LATEST REVISION DATE 04-12	APPROVED BY BRIDGE ENGINEER <i>Thomas E. Mc Donnell</i>		
		STANDARD DESIGN - 40' ROADWAY, THREE SPAN BRIDGE PRETENSIONED PRESTRESSED CONCRETE BEAM BRIDGES AUGUST, 2009	
		ABUTMENT BACKFILL DETAILS A & B BEAMS - 0° SKEW	H40-92-06

ABUTMENT PLAN WITHOUT WING EXTENSIONS

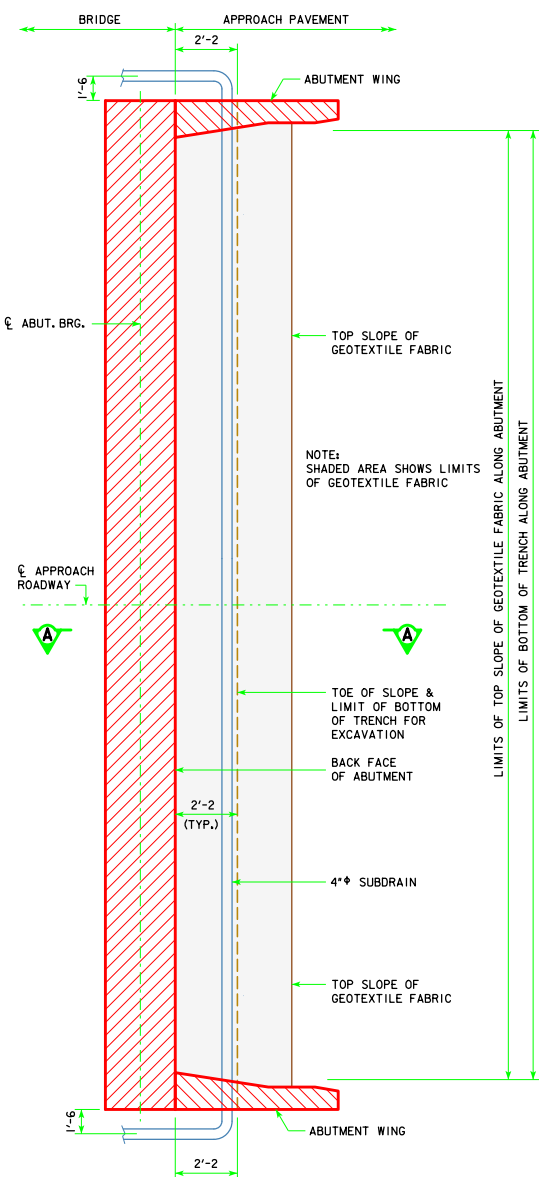
REVISED 04-12 - EXCAVATION LIMIT ON THE FRONT FACE OF THE ABUTMENT WAS CHANGED TO A 3'-0" LIMIT. THE APPROACH FILL WAS IDENTIFIED AS THE GRADING SURFACE.
